Technical Bulletin

DP02	TB0013-2007	Elan Motorsports Technologies	
From:	Christian Rushforth		
Subject:	<i>Front Dive Planes option</i>	Date:	April 9 th , 2007

Attention all Elan DP02 teams

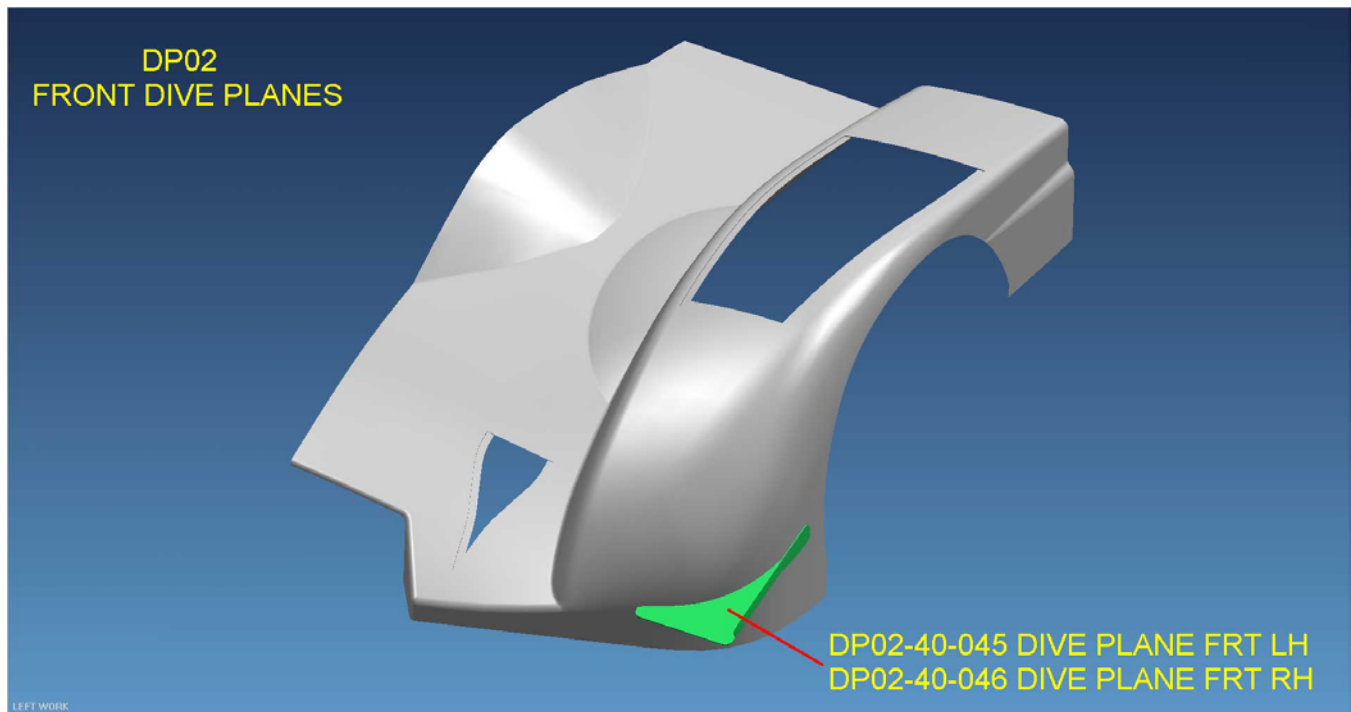
Available to order are optional front dive planes, Part No. DP02-40-045 / 046, the part is expected to add front down force and drag.

Note: The Dive Planes shown are homologated components, these are the only versions that can be used in the specified location (see sheet 2 for dimensions). Under no circumstances is the dive planes shape or position to be modified.

LHS FRONT FENDER

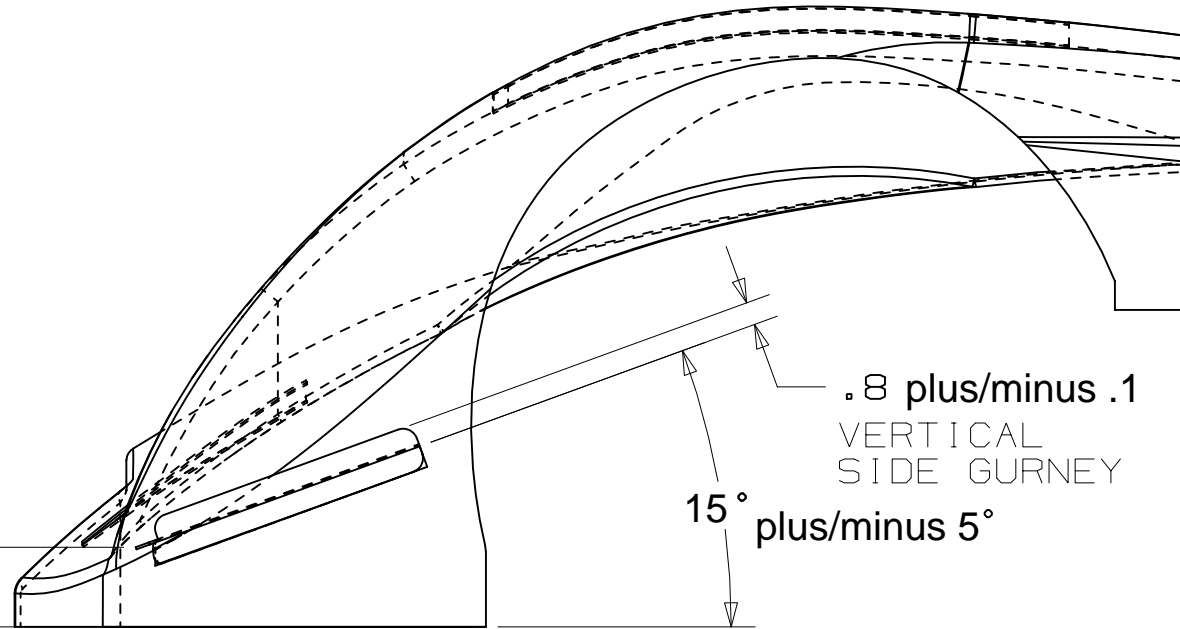
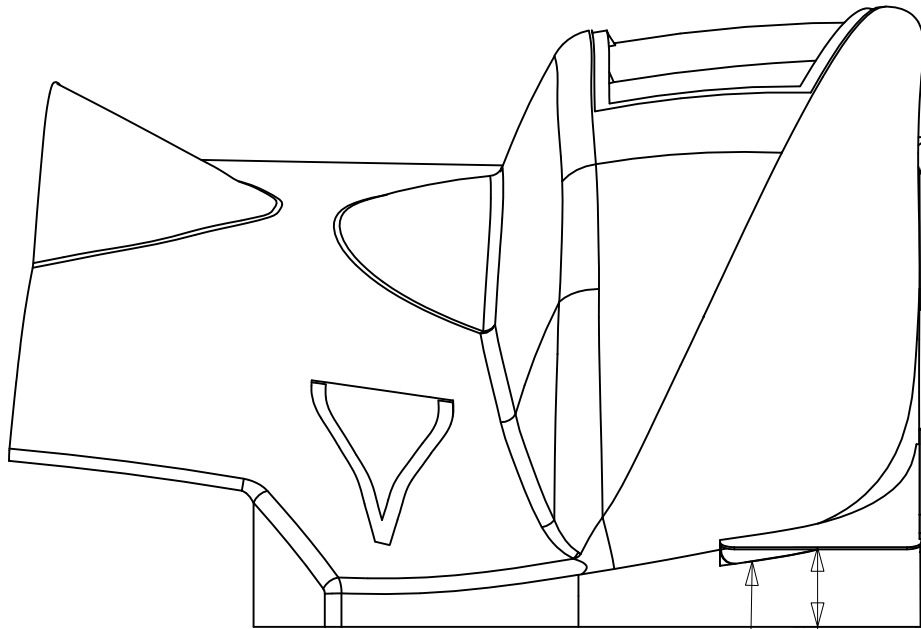
DIMENSIONS SHOWN ARE TO TOP DIVEPLANE SURFACE
Reference Plane is top of splitter

BOLT TO FENDER USING FLANGE

3" plus/minus .5"

Dive Plane is 10" long
in side view (Side Gurney)

.8 plus/minus .1
VERTICAL
SIDE GURNEY

15° plus/minus 5°
